## CASES 980-S-20 & 981-V-20

SUPPLEMENTAL MEMORANDUM #1

Petitioner: **Greg Allen, d.b.a. Prairie States Warehouse Inc., via agent Tim Mohr**

Request: **Case 980-S-20**

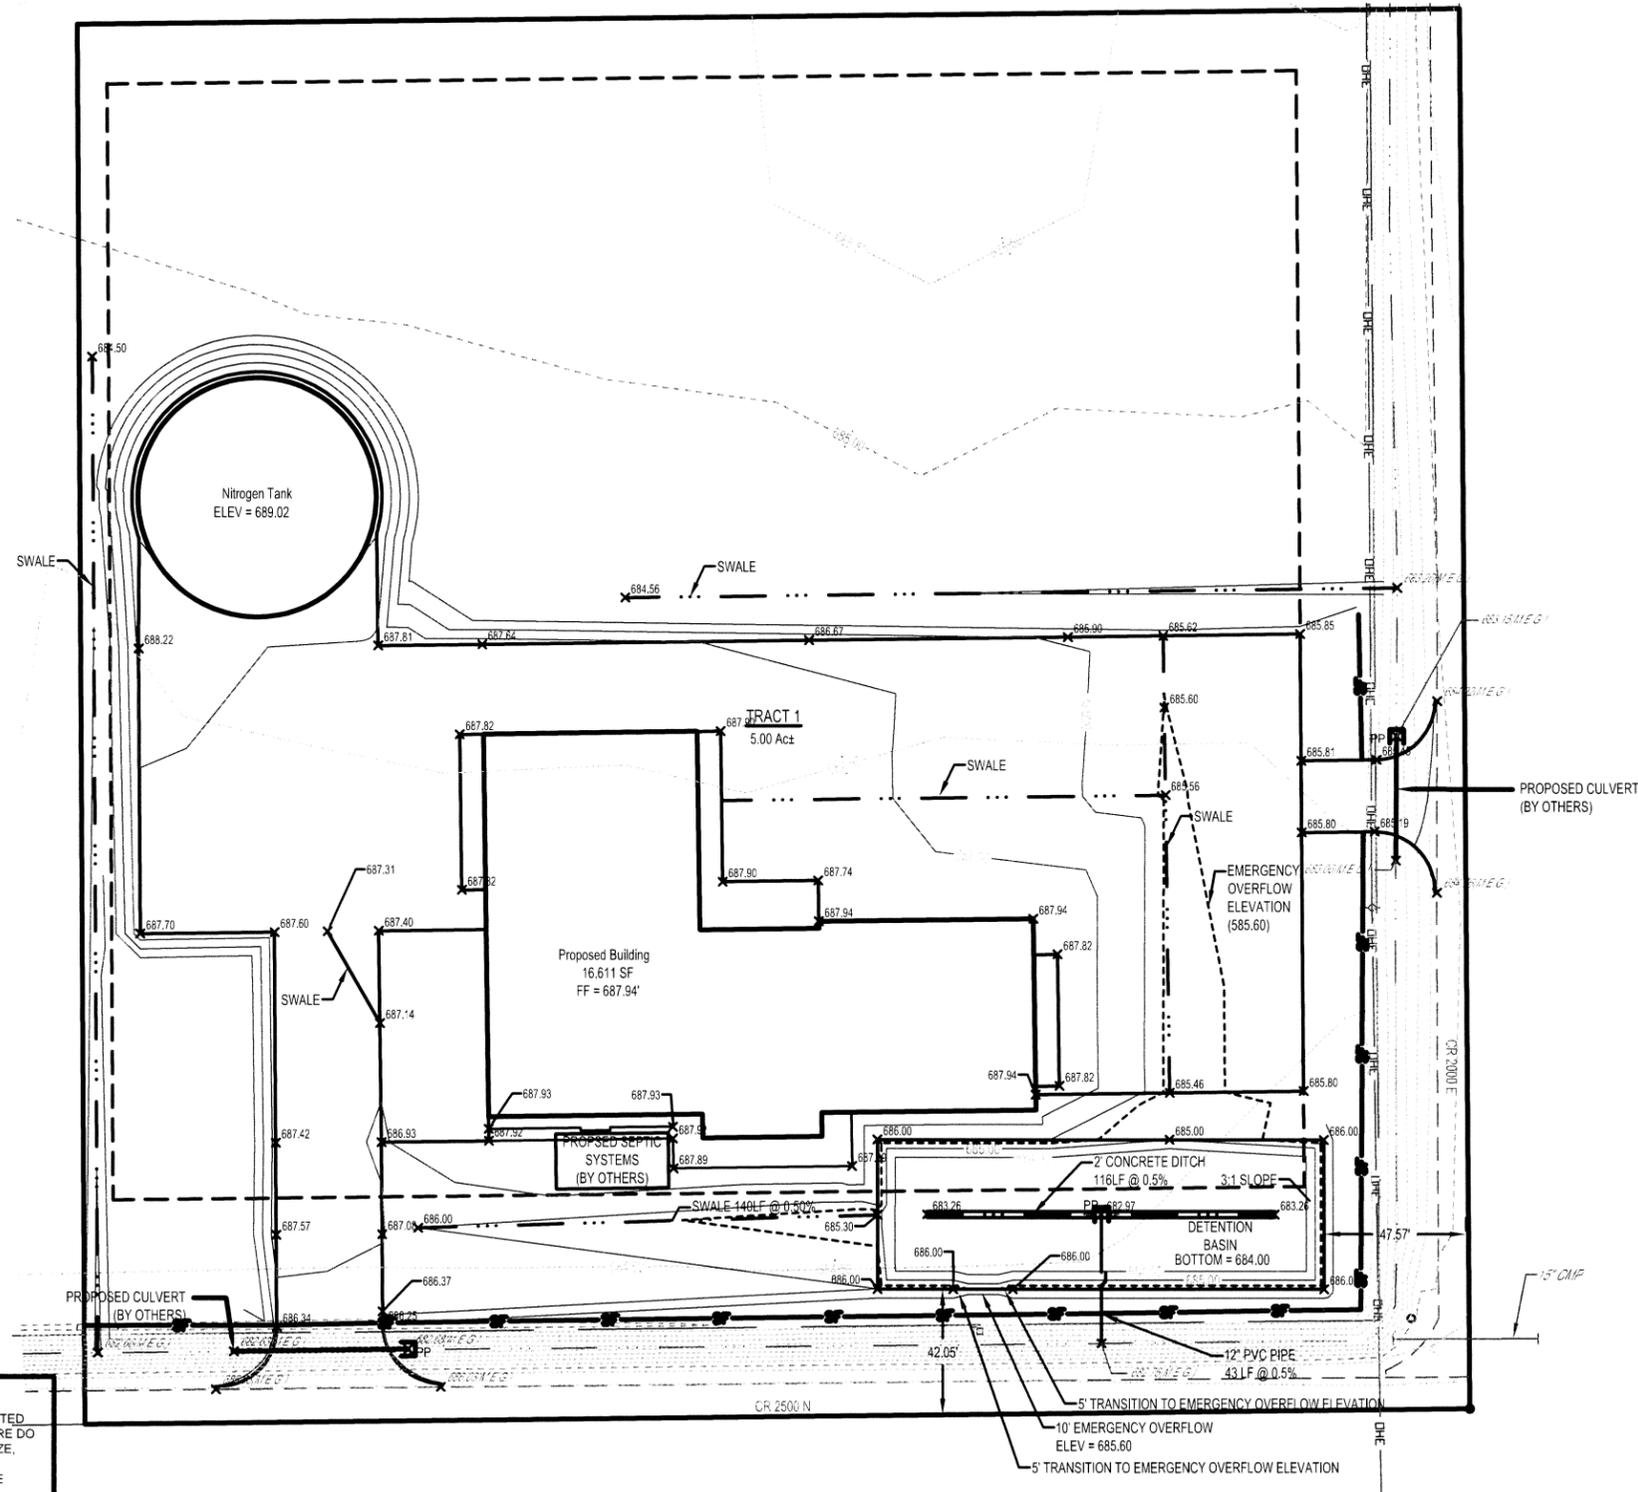
- b. Mr. Blue stated that he has the following concerns about the proposed drainage basin location:
    - (a) Having the basin that close to the ROW really restricts our ability to ever do a roadway improvement through there in the future. Typically an improvement consists of widening the shoulders and ditches for safety purposes and to accommodate bigger equipment. Typically we end up acquiring 40 feet of ROW on each side of the road (80 feet total) for those types of projects. Therefore, I am opposed to the variance and would prefer the basin be no closer than 40 feet from the center line.

- (b) The septic tank should also be no closer than 40 feet due to the same issues.
    - (c) We would like a concrete culvert pipe in the driveway so that it doesn't require maintenance in the future. The culvert will need to be permitted through our department for size and type.

Susan: the ROW for 2500N is 60' total, but I am concerned about a couple of things:

- 1) Having the basin that close to the ROW really restricts our ability to ever do a roadway improvement through there in the future. Typically an improvement consists of widening the shoulders and ditches for safety purposes and to accommodate bigger equipment. Typically we end up acquiring 40' of ROW on each side of the road (80' total) for those types of projects. Therefore, I am opposed to the variance and would prefer the basin be no closer than 40' from the center line.
- 2) The septic tank should also be no closer than 40' due to the same issues.
- 3) I know you didn't ask, but we would like a concrete culvert pipe in the driveway so that it doesn't require maintenance in the future. The culvert will need to be permitted through our department for size and type.

Prairie States West has a ZBA hearing on 10/15. Their proposed fertilizer storage facility would be located on the NW corner of the intersection of CR 2500N (CH 11) and CR 2000E. They recently submitted a Storm Water Drainage Plan that appears to show a wet basin very close to the County Highway 11 right-of-way. I'm requesting a couple of things:

1. Could you please verify if the CR 2500N ROW at that location is 60 feet?
2. Could you please respond to this email saying if you DO or DO NOT object to a variance that would allow the basin to be 33 feet from street centerline of CH 11 and 35 feet from the street centerline of CR 2000E?

- C. A revised Storm Water Management Plan received October 14, 2020, reduced the requested variances by moving the drainage basin inward from the road rights-of-way:
- (1) The proposed detention basin would be approximately 42 feet from the street centerline and approximately 12 feet from the road right-of-way line of CR 2500N (County Highway 11).
  - (2) The proposed detention basin would be approximately 47.57 feet from the street centerline and approximately 21.57 feet from the road right-of-way line of CR 2000E.

- (c) A revised Storm Water Drainage Plan was received from Milano & Grunloh Engineers on October 14, 2020.
  - i. The revised drawing shows the drainage basin shifted north nine feet and west 12.57 feet.
  - ii. As proposed, the basin is still closer than the minimum required front yard and setback from the street centerline.
  - iii. Variance parts B and C of Case 981-V-20 have been adjusted to show this difference.
